Watts Bar Nuclear Plant, Unit 2
NRC Docket No. 50-391

**Subject: Watts Bar Nuclear Plant (WBN) Unit 2 – Safety Evaluation Report
Supplement 22 (SSER22) - Response to NRC Required Action Items**

ENCLOSURE 1

Response to Action Items From Appendix HH of NUREG-0847, Supplement 22

FIGURE 1
WATTS BAR UNIT 2, CYCLE 1
REFERENCE CORE LOADING PATTERN

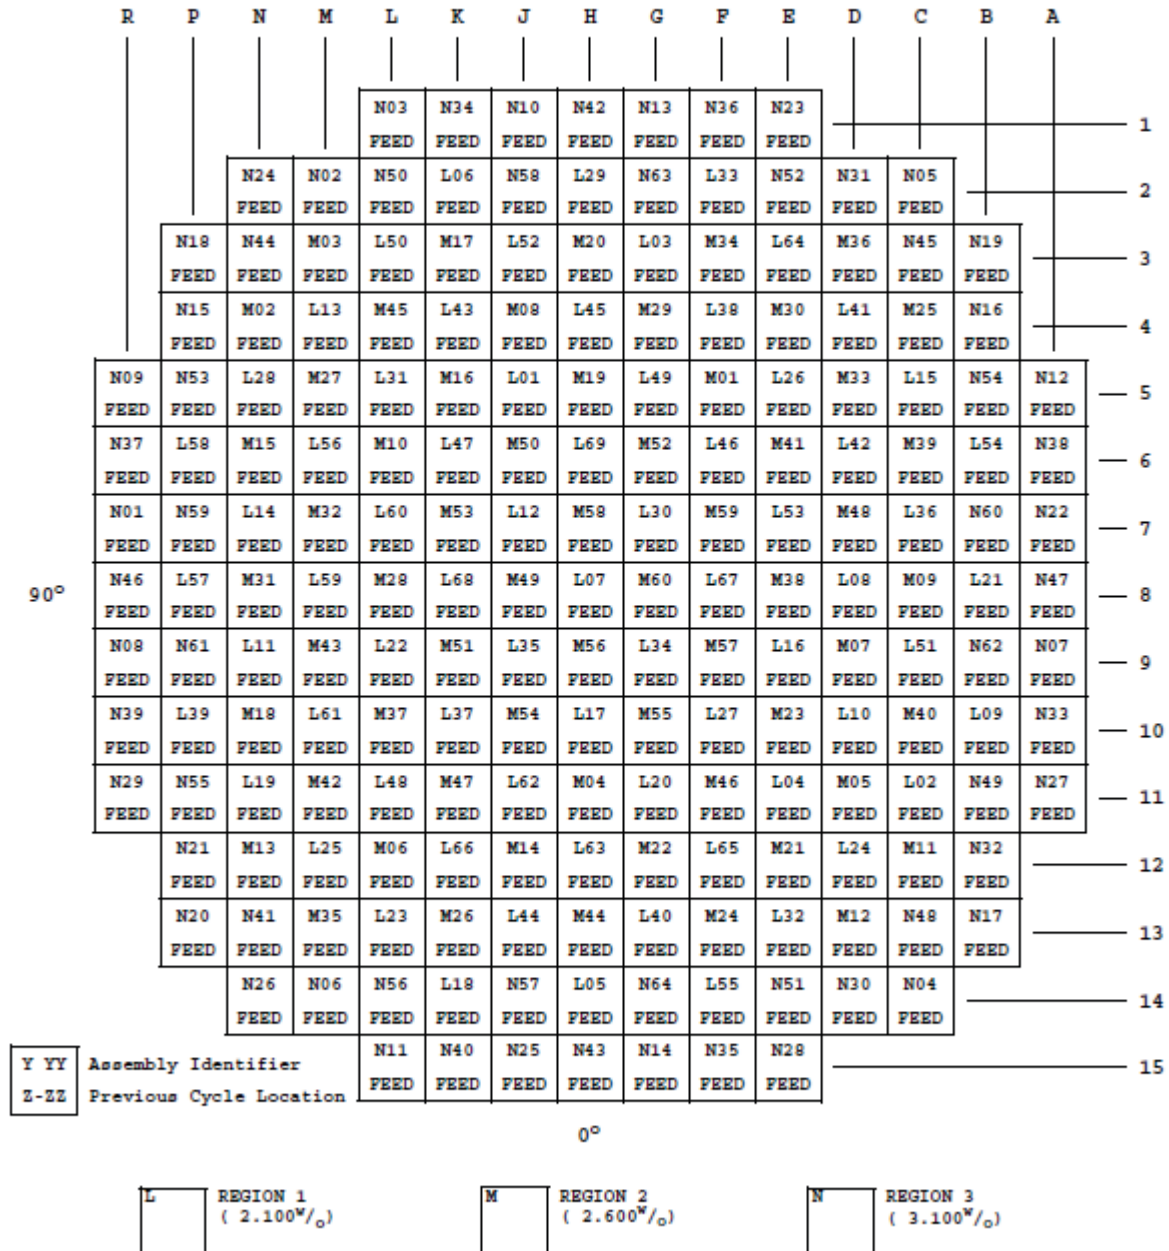
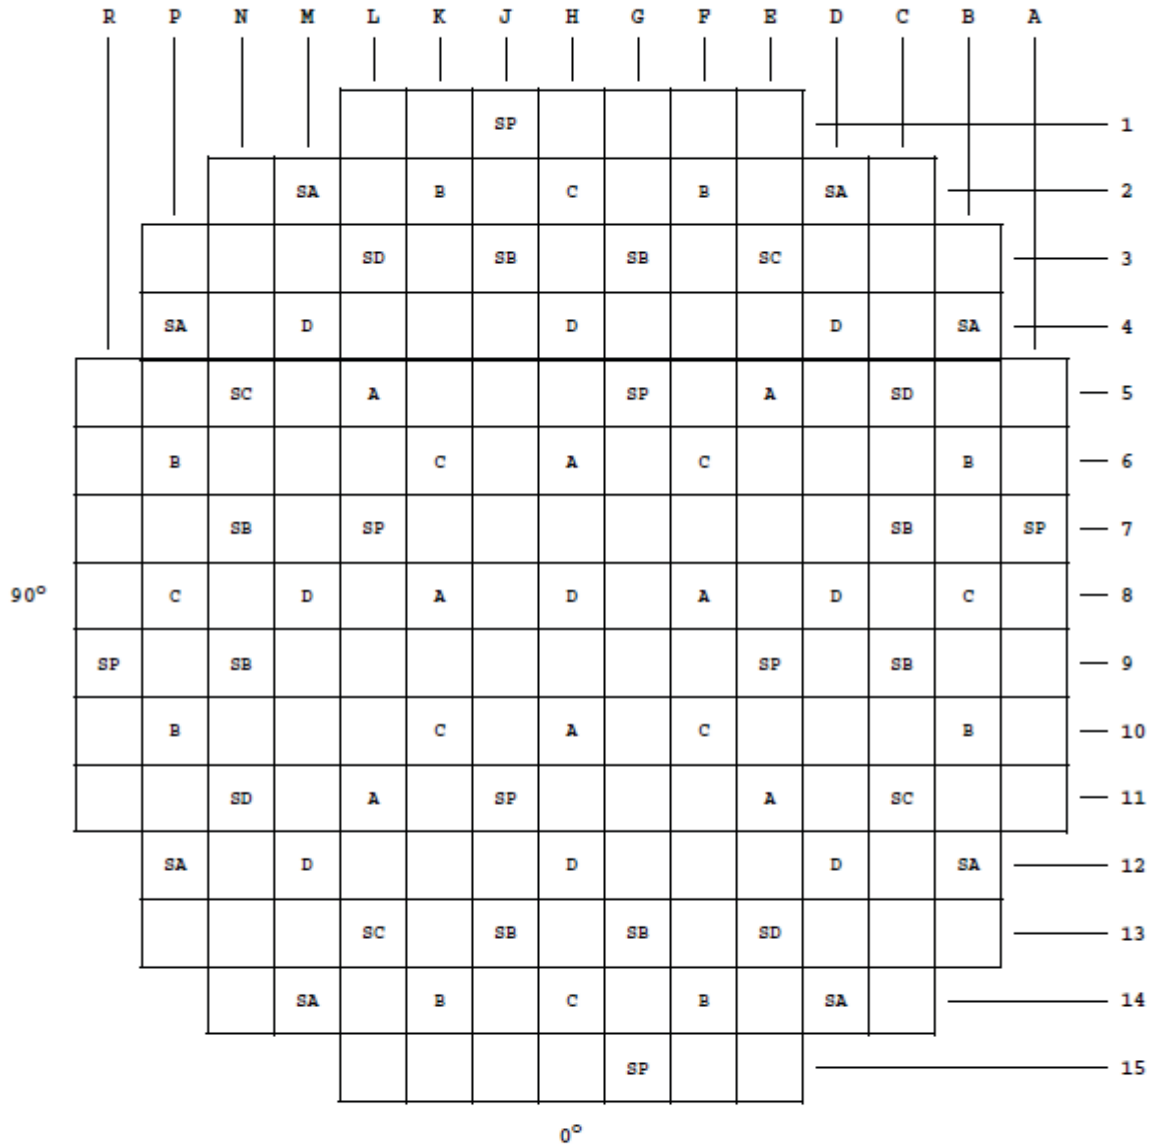
8. *Verify rod control system operability during power ascension. TVA should provide a pre-startup map to the NRC staff indicating the rodded fuel assemblies and a projected end of cycle burnup of each rodded assembly for the initial fuel cycle 6-months prior to fuel load. (NRC safety evaluation dated May 3, 2010, ADAMS Accession No. ML101200035)*

Response: Attachment 1 provides the requested pre-startup map indicating the rodded fuel assemblies and the projected end of cycle burnup of each rodded assembly for the initial fuel cycle.

Figure 1 provides the core loading pattern for WBT01, while Figure 2 provides the control and shutdown rod locations. Figure 3 provides assembly average burnups for all core locations, at the maximum analyzed Cycle 1 burnup (17675 MWD/MTU).
